Amendment No. 2
to
AS/NZS 1698:2006
Protective helmets for vehicle users

REVISED TEXT

SUMMARY: This Amendment applies to Clauses 5.3, 5.4, 5.6, 7.4, 7.5 and 7.7.2 and Figure 1.

FIGURE 1 INTERNAL AND EXTERNAL PROJECTIONS

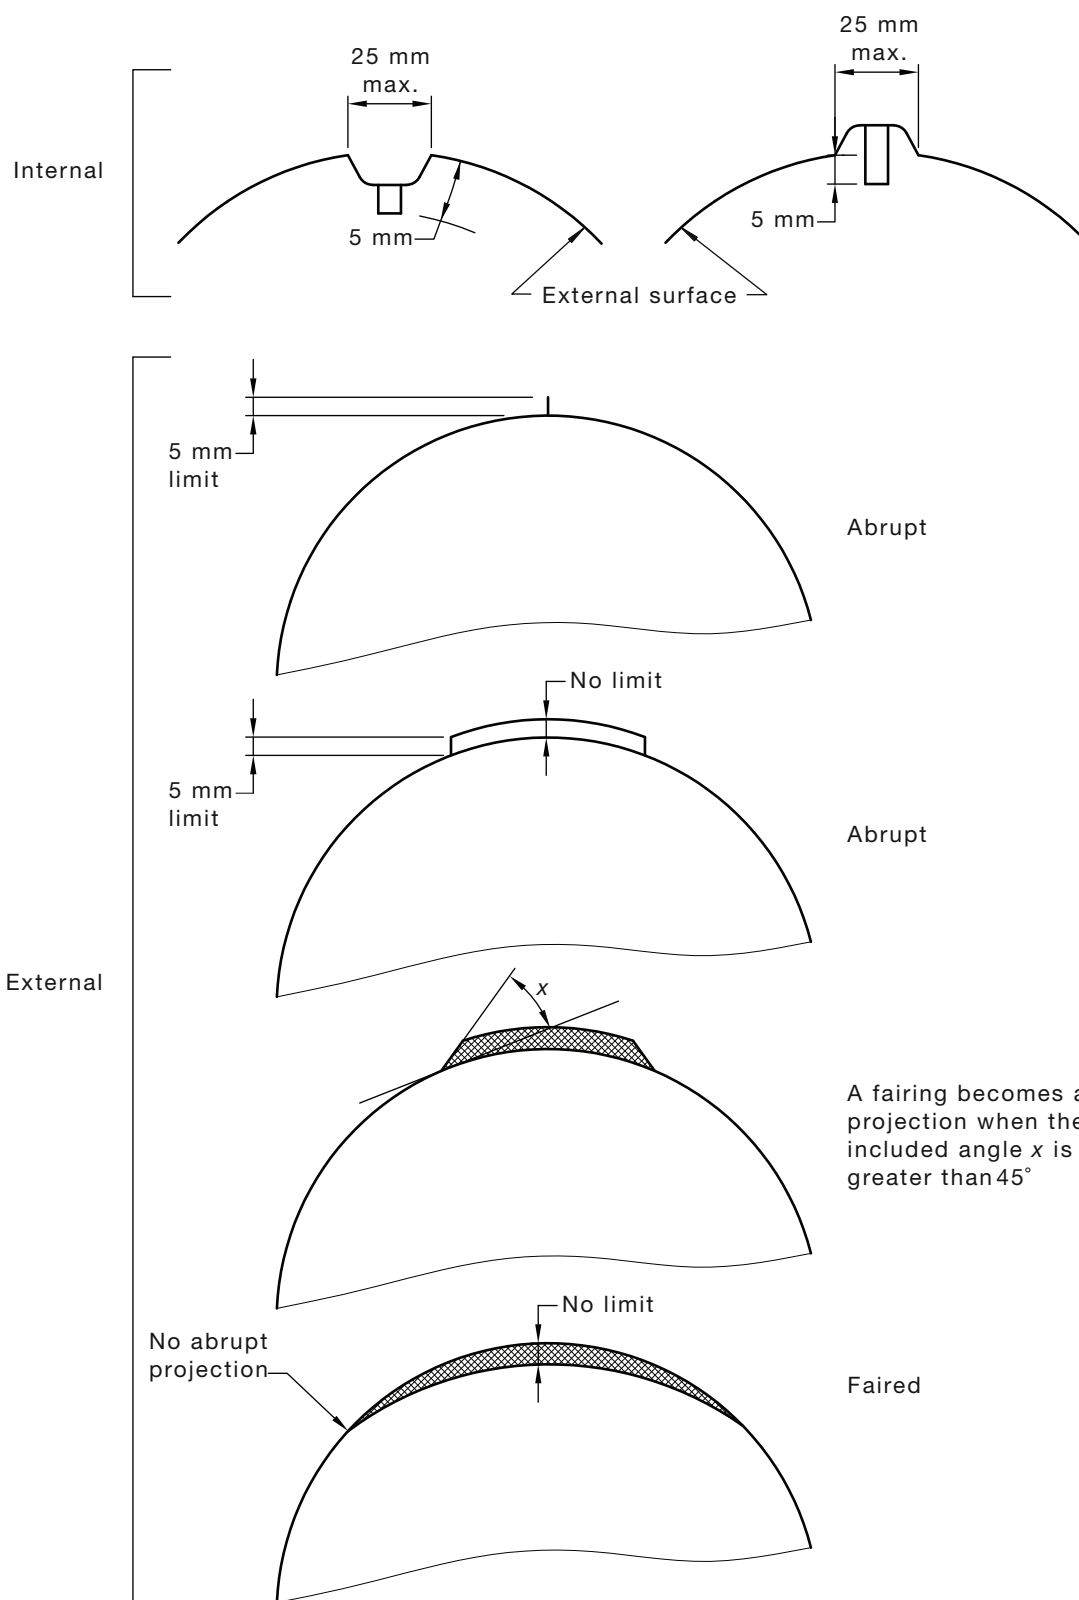
Rigid projection and irregularities on the continuous curve of the outer surface of the helmet, except for ventilation holes and associated depression, shall not be greater than 5 mm in height when measured normal to the general outer surface of the helmet (see Figure 1).

Delete Figure 1 and *replace* with the following:
